DA Number DA 2025 / 00097

Proposal Residential - Construction of a Shed

Location 12 Ti-Tree Drive, Ansons Bay

RE: DA 2025/00097 REQUEST FOR INFORMATION

View of existing rainwater storage tank and boat to be stored in shed

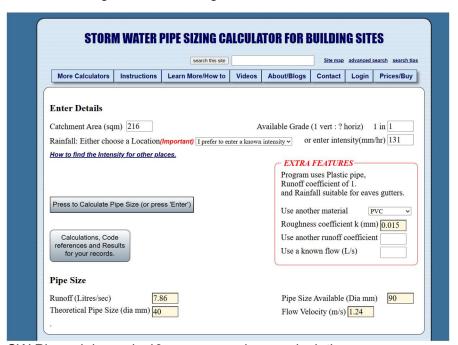
Currently there is no stormwater management system for Ansons Bay, roof water is collected in a rainwater storage tank and the overflow is directed to the open culvert in the street. The existing rainwater storage tank has a 90mm overflow, the belowground SW line is 100mm to a pit, and has a drainage point for charged water from the house.

It is intended for the shed stormwater to be dealt with in the same manner. The existing water harvesting tank is 2400mm litres.

SW Pipe minimum is 40mm as per above calculations.
